**VALUE ENGINEERING FINAL REPORT, PROJECT: REMEDIAL ACTIONS
AT OPERABLE UNIT 1 - FERNALD, RECORD OF DECISION PLAN, JULY
20, 1995**

**VE STUDY TEAM DOE-FEMP
65
REPORT**

REMEDIAL ACTIONS AT OPERABLE UNIT 1 - FERNALD

RECORD OF DECISION PLAN

Figure 6. Remediation System Conceptual Design

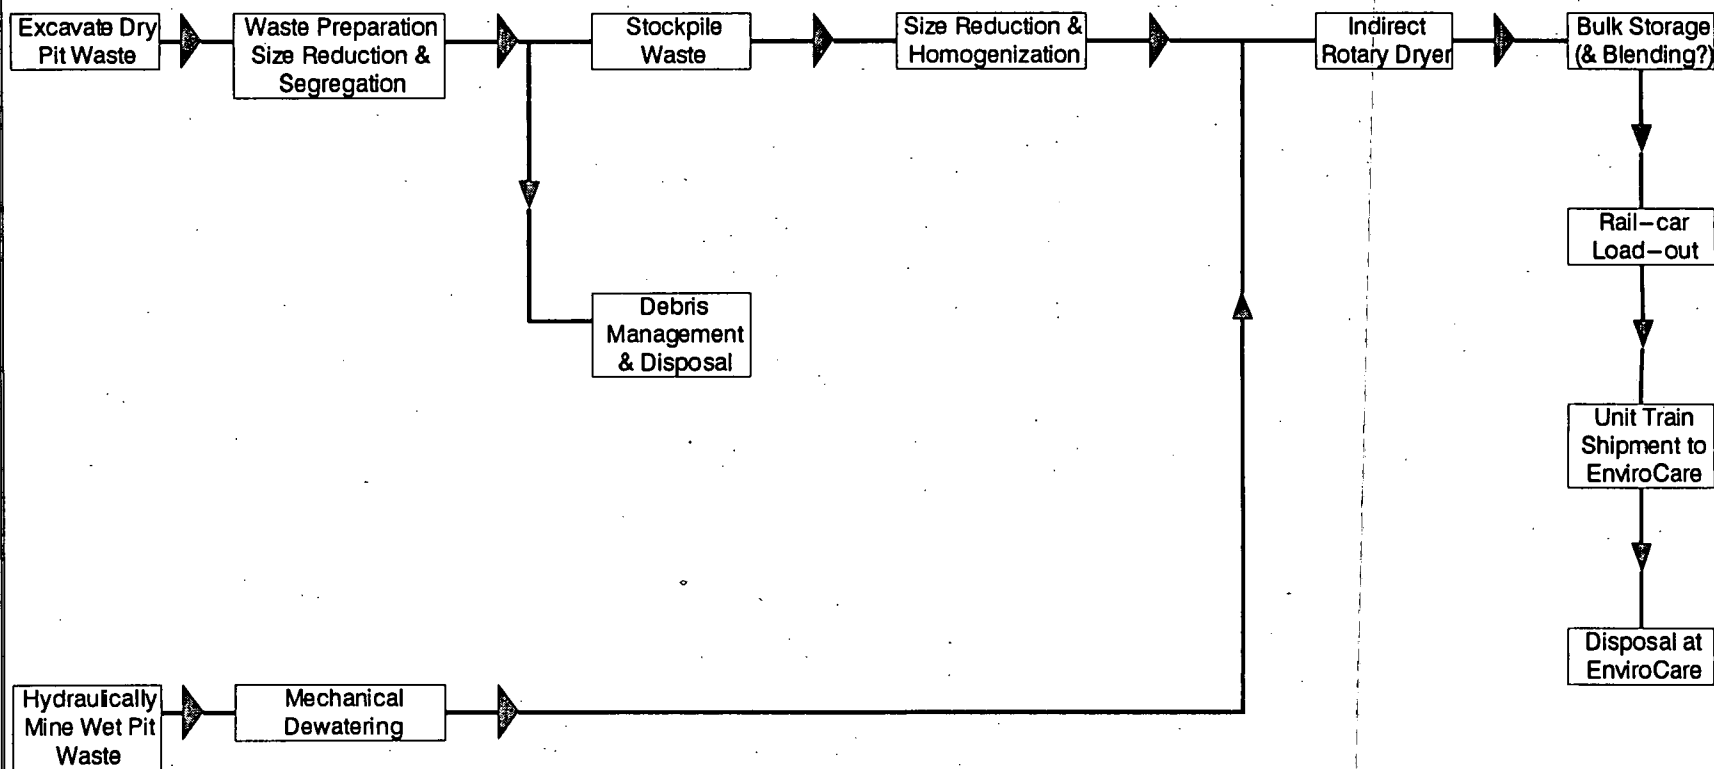
The current preliminary design utilizes a single IHRD to reduce the moisture level of all OUI materials (approximately 653,500 dry tons) to 10 percent moisture prior to shipment to Envirocare for disposal. Moisture content is significant from the standpoint of transportation costs and possible surcharges from Envirocare for not meeting optimum specifications. It may also be a safety issue, since dusting will occur if over-drying occurs. The excavation plan presented to the VEST proposed to remove about 20 percent of the material by slurrying. The slurried material will be thickened to 40 percent solids and then dewatered to 65 percent solids using a vacuum filter. Slurry removal will, by design, remove any debris larger than 2- to 4-inches (exact size at time of study was still being determined). The remaining 80 percent will be excavated, screened to 6-inches, and stored for feeding to the drier. The existing plan calls for shredding the debris to less than 4 inches. The excavated and screened soil, along with the minus 4-inch shredded debris, is then fed to the IHRD.

The current concept ROD design utilizes an IHRD for drying all the OUI media. Unfortunately, on a wet basis, it is estimated that 15 to 40 percent of the materials will have moisture content in excess of 50 percent. These wet materials are not well suited for an IHRD, because of its low thermal efficiency of 3,000 to 3,500 BTU's to remove a pound of water.

Also, an IHRD is slow and its responsiveness is not robust. The typical residence time to dry is 20 to 60 minutes. Because of feed differences and variations in feed rate, controlling the exit product moisture to match the target 10 percent with any attained precision may be very difficult. Therefore, as a part of this proposal, it is recommended that a product cooler/moisturizer be added at the product discharge from the IHRD. The cooler/moisturizer is essentially a closed mixer to add water back to the treated soil, that provides the needed control of the treated soil moisture content.

This proposal recommends installing two different dryer type designs; an IHRD similar to the current design, except smaller and less expensive; and a pulse dryer designed for drying pumpable fluids (slurries). The pulse drier characteristics allow it to accept almost any feed stream that can be pumped through a 1.5-inch-diameter pump. Further, it is not well suited to producing product below 5 percent residual moisture. This is actually for the project, since the plan is to dry to 10 percent moisture. Also, the pulse dryer is ideally suited for media that is excavated using the slurry method and it is energy efficient, since it only requires approximately 1,400 BTU's to remove a pound of water. Unfortunately, from a contractual viewpoint, the pulse dryer reviewed within this study was only produced by one manufacturer in the United States. A search for other dryer suppliers or designs will be necessary to meet Government requirements.

The proposed IHRD would be capable of processing approximately 20 tons per hour for feed with 23 percent moisture and 11 tons per hour at 45 percent moisture. The pulse drier would be sized for 12,000 pounds per hour of water, or about 10 tons per hour feed at 65 percent moisture and approximately 7.5 tons per hour at 80 percent. This would provide a total process capacity of about 18.5 to 30 tons per hour with a wet feed. At these rates drying of all material would be possible in 5 to 8 years, based on 7,500 hours per year.

FUNCTION ANALYSIS SYSTEM TECHNIQUE (FAST) DIAGRAM

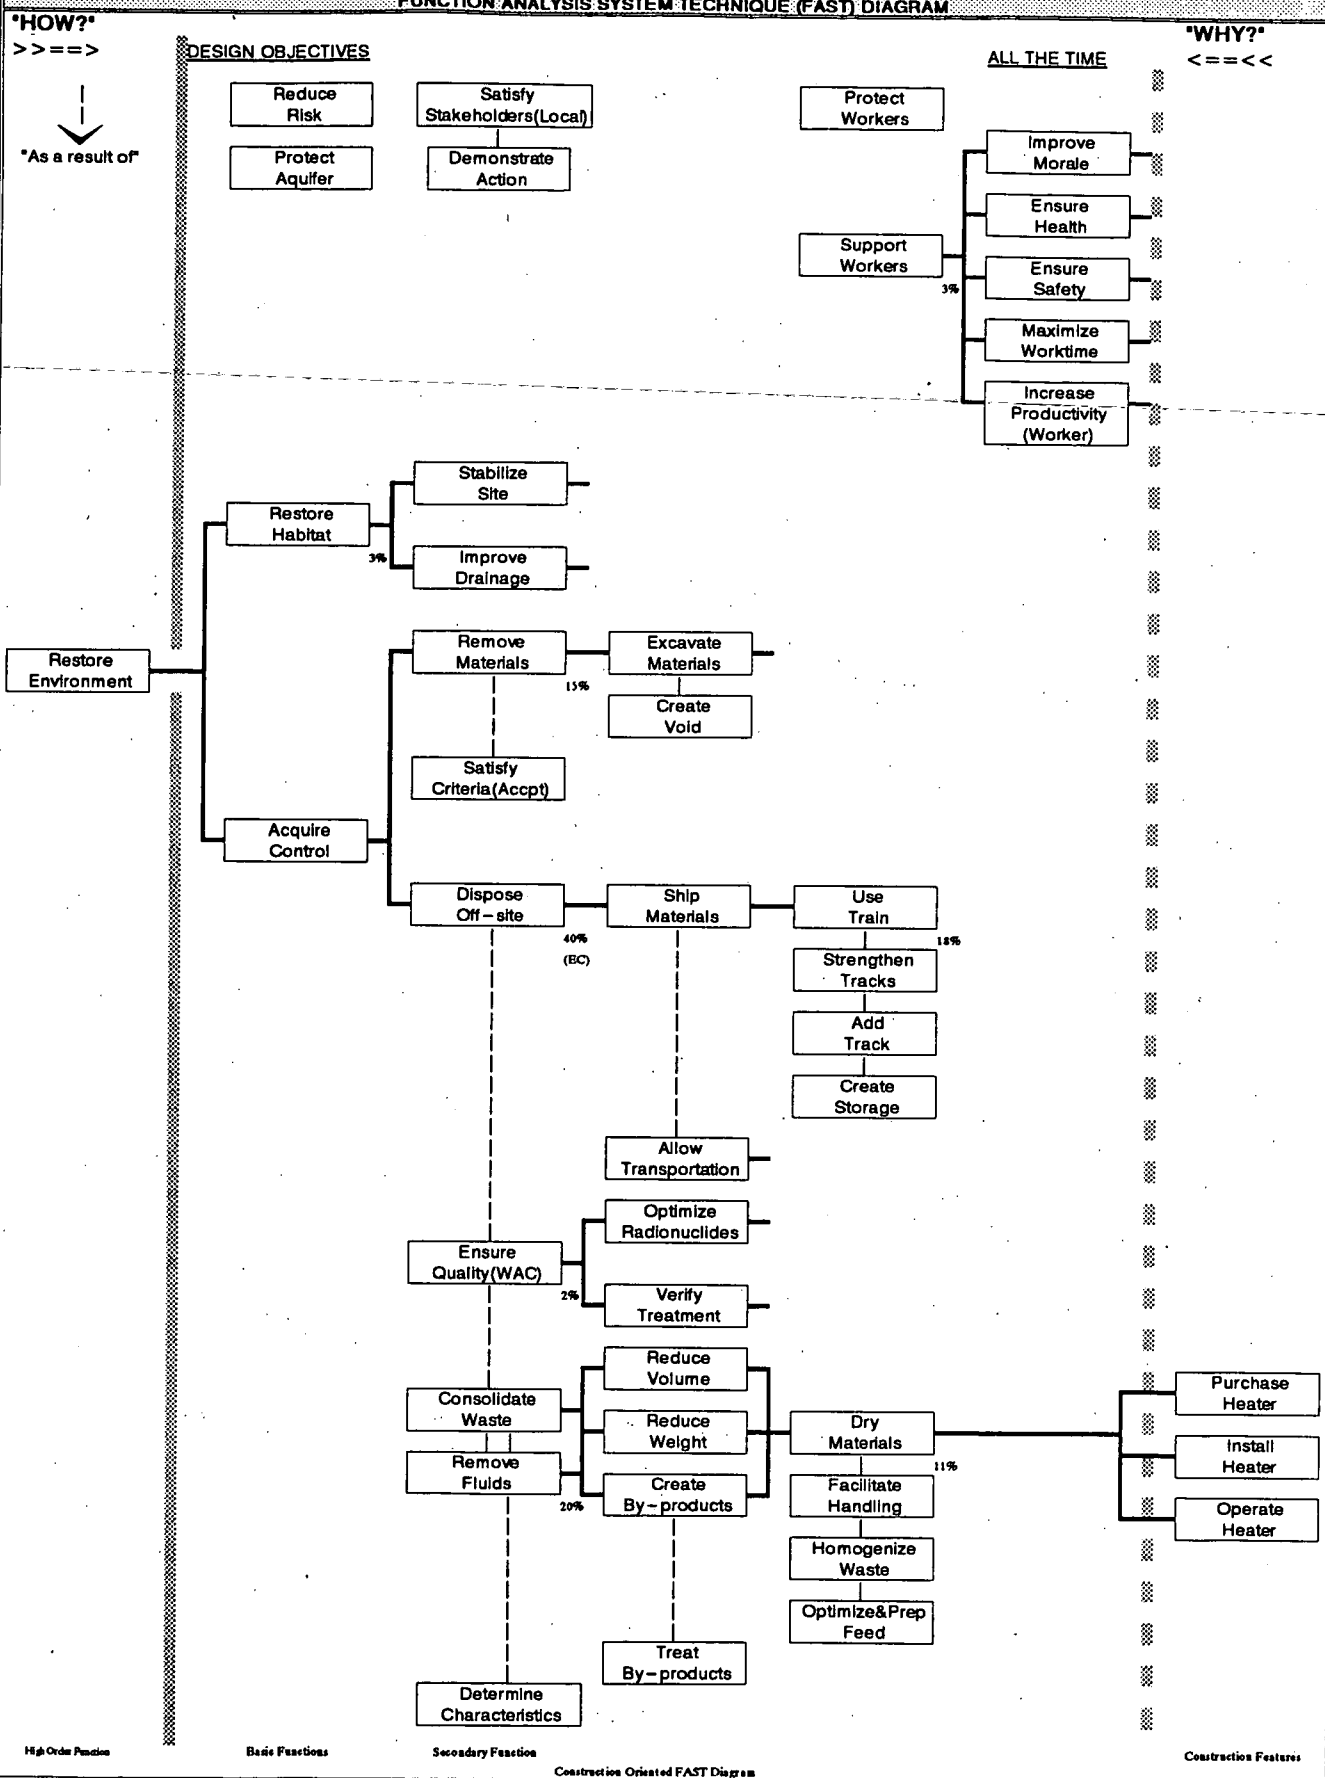
The results of the FAST indicated that the bulk of the project (more than 90 percent) is related to the decision to place the material off-site. The largest portion of the costs are in the disposal fees (about 40 percent) with another 18 percent used in transporting (by rail) from Fernald to the Utah site.

The supporting function Consolidate Waste is not on the critical path and is therefore defined (in VE terms) as a "potential value mismatch" due to its large cost, between 12-20 percent in relation to the project, and the fact that it is not a primary purpose for the project. This indicated that a concentration of study team efforts (or design team efforts) to avoid or reduce the cost of this feature should add large value related increases to the project. (Provided the effect on the related critical path function Dispose Off-site costs were unaffected or could be reduced within the effort.)
